Georgian Forest Elementary School Addition, Mandatory Referral, MR2012002

description

- 3100 Regina Drive, Silver Spring, MD
- R-90 zone, 11.03 acres, 1989 Master Plan for the Communities of Kensington-Wheaton
- A two-story addition to accommodate current and projected enrollment, and to modernize the layout of the school interior to allow for enhanced educational programs.

MANDATORY REFERRAL SITE PLAN

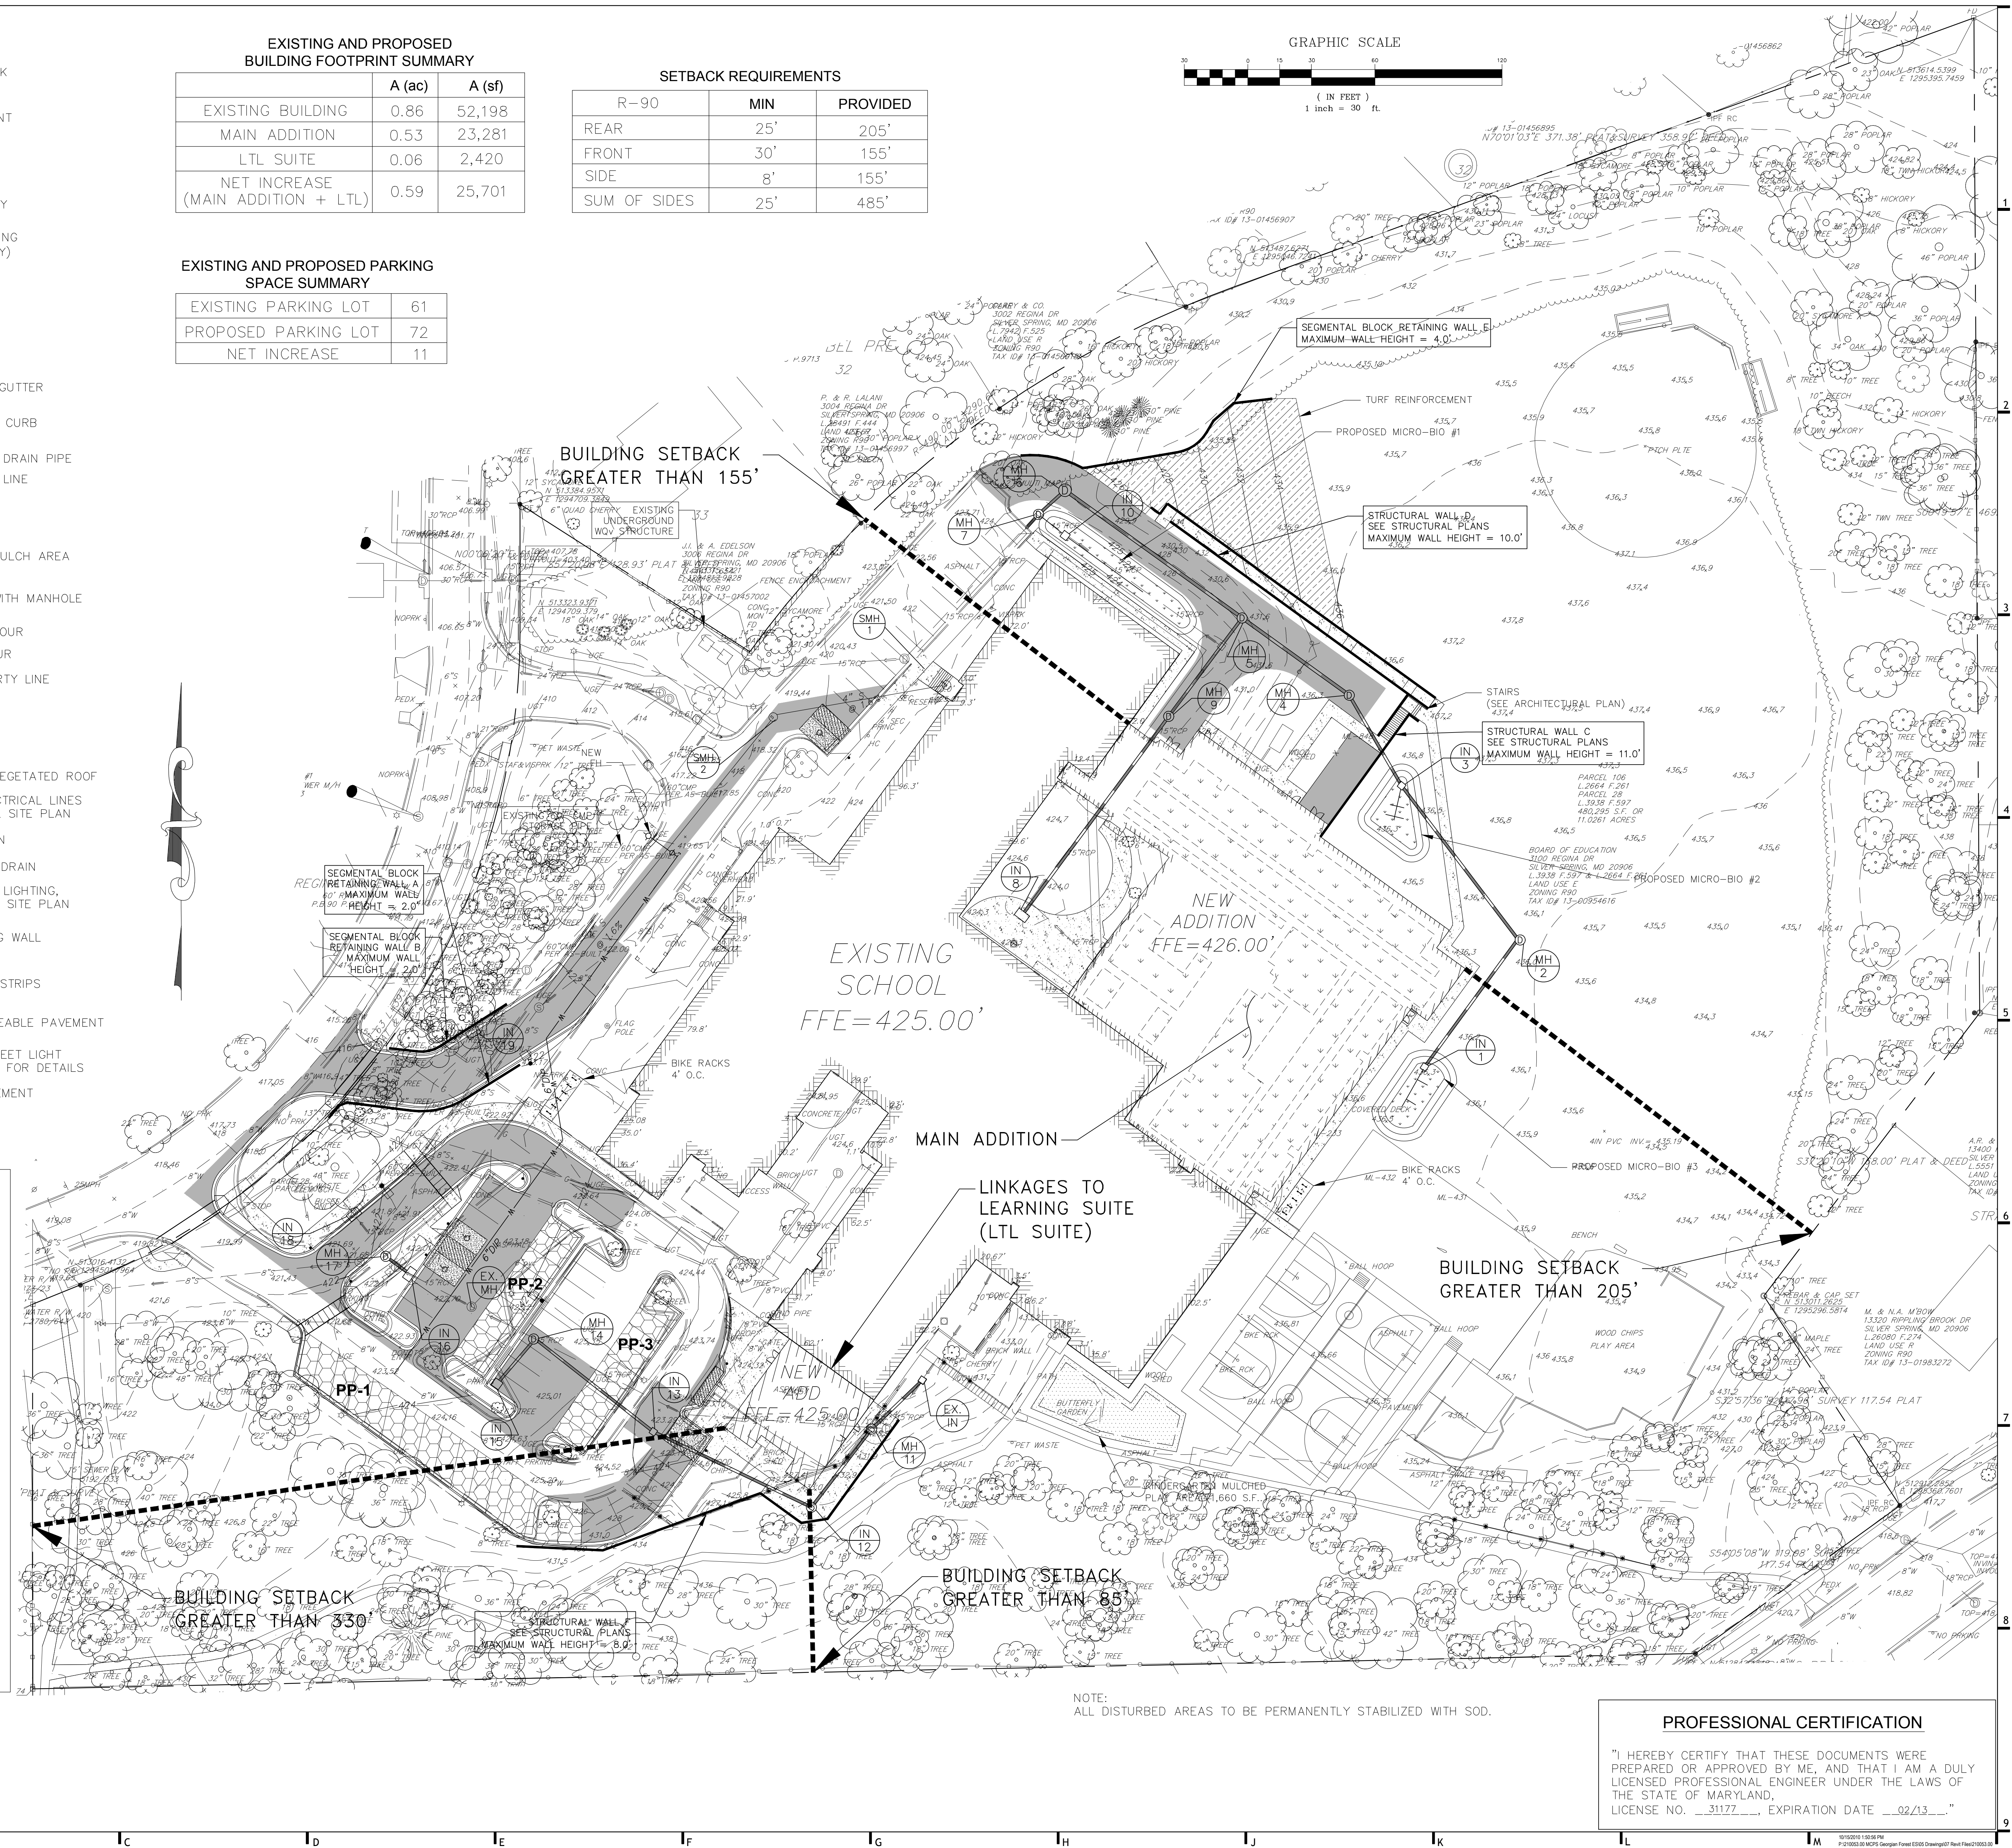
- The applicant must obtain a final stormwater management approval from the Department of Permitting Services.
- Provide adequate signage in order to maintain consistent traffic flow between school buses and vehicular traffic into the school site.

MCPS proposes to improve the vehicular circulation by separating the different types to vehicular movements. Below are the proposed vehicular access points from Regina Drive:

1. Southern Driveway #1: Will function as only the entry/exit point to/from the student drop-off/pick-up loop and the main south side parking area.
2. Northern Driveway #2: Will continue to function as the exit from the bus loop and the entry/exit point to/from the north side parking area.
3. Proposed New Middle Driveway #3: Will be a new entry point for the bus loop.

1. A second 5-foot lead-in sidewalk from the existing sidewalk along Regina Drive into the southern parking area.
2. Handicapped ramps along existing sidewalk in front of the school’s property.
3. Designated internal 5-foot wide pedestrian paths with handicapped ramps through the student drop-off/pick-up loop.

LANDSCAPE PLAN

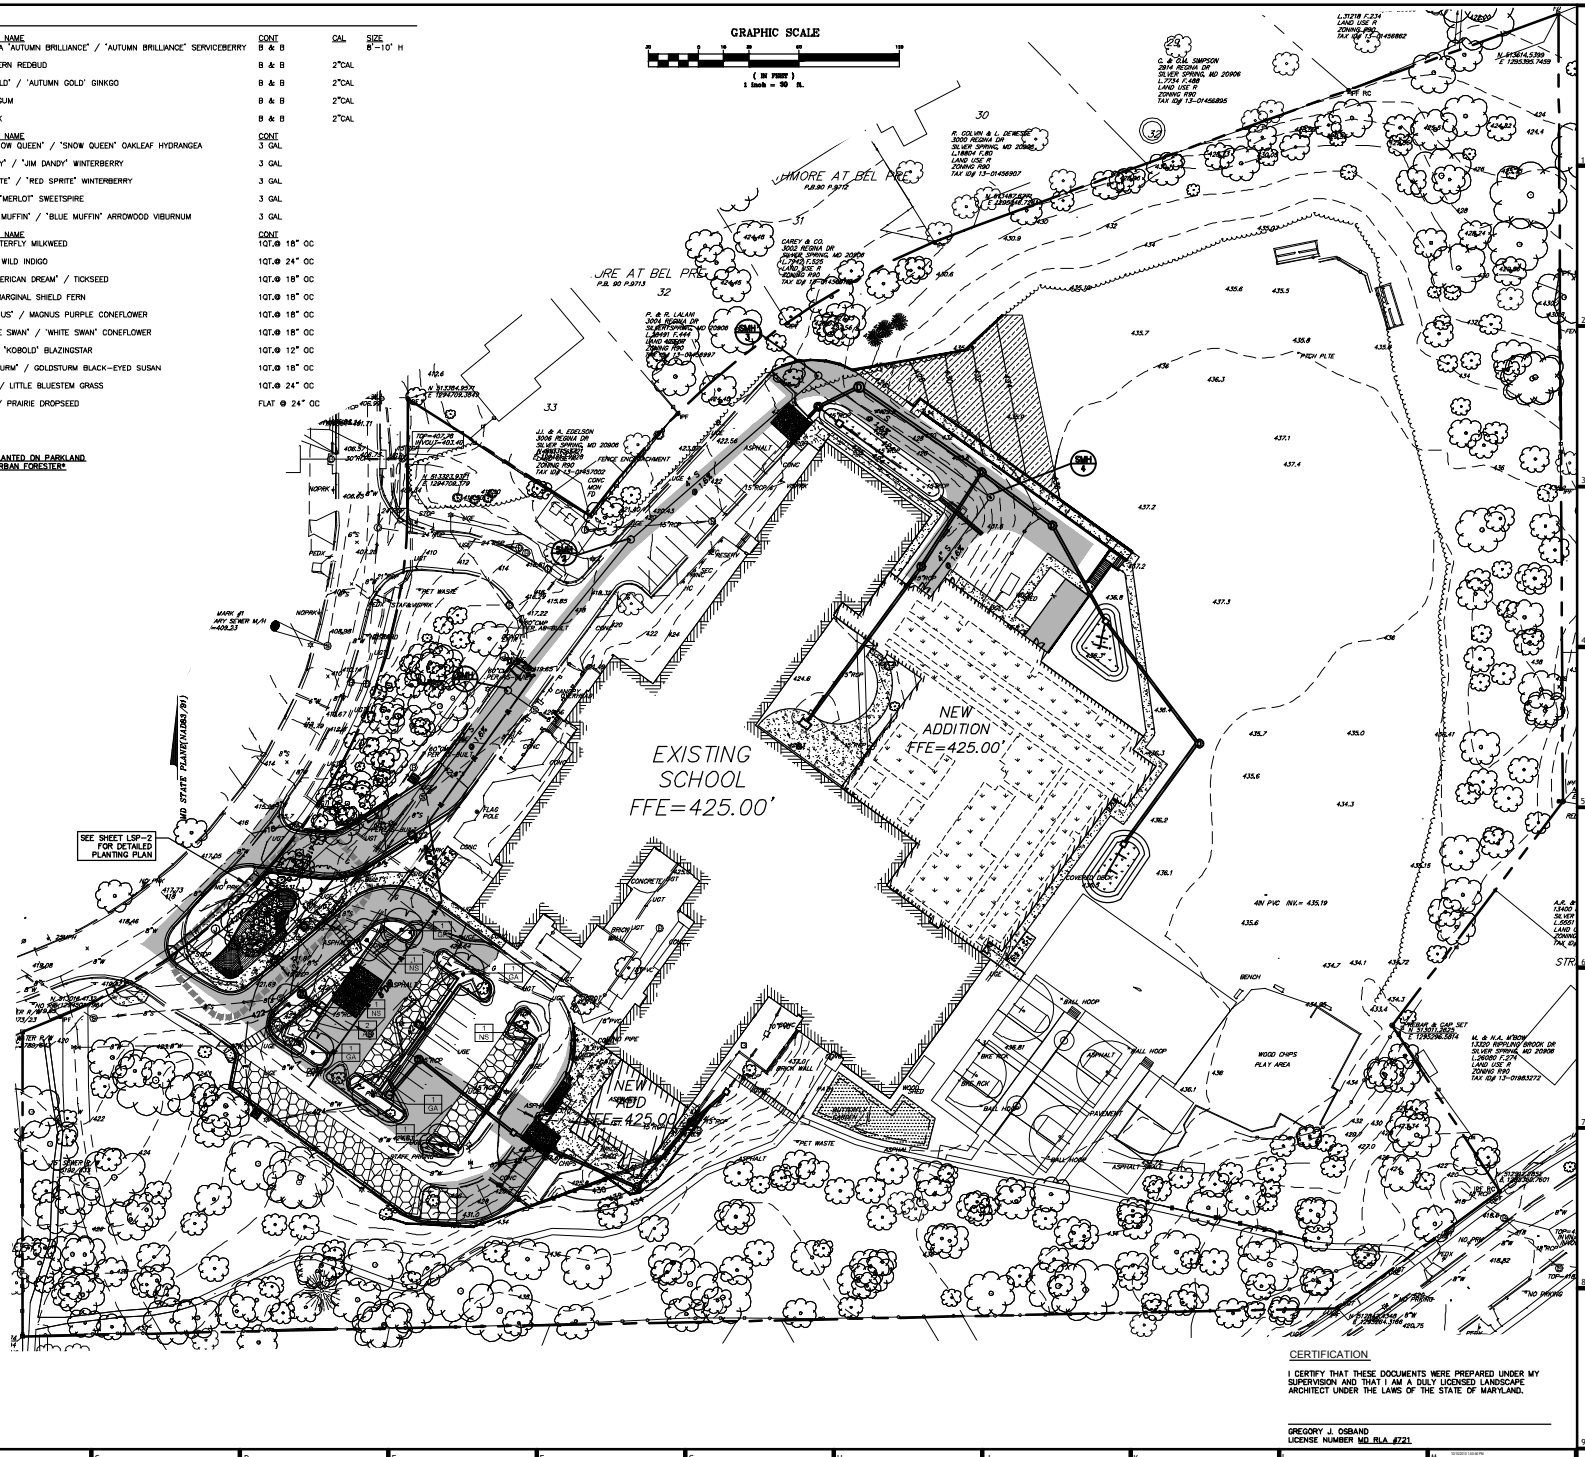
5. Landscaping shown on the approved Landscape Plan as part of the approved Site Plan are for illustrative purpose only and may be changed at the time of detailed plan review of the Sediment Control/Storm Water Management plans by the Mont. Co. Department of Permitting Services, Water Resources Section.
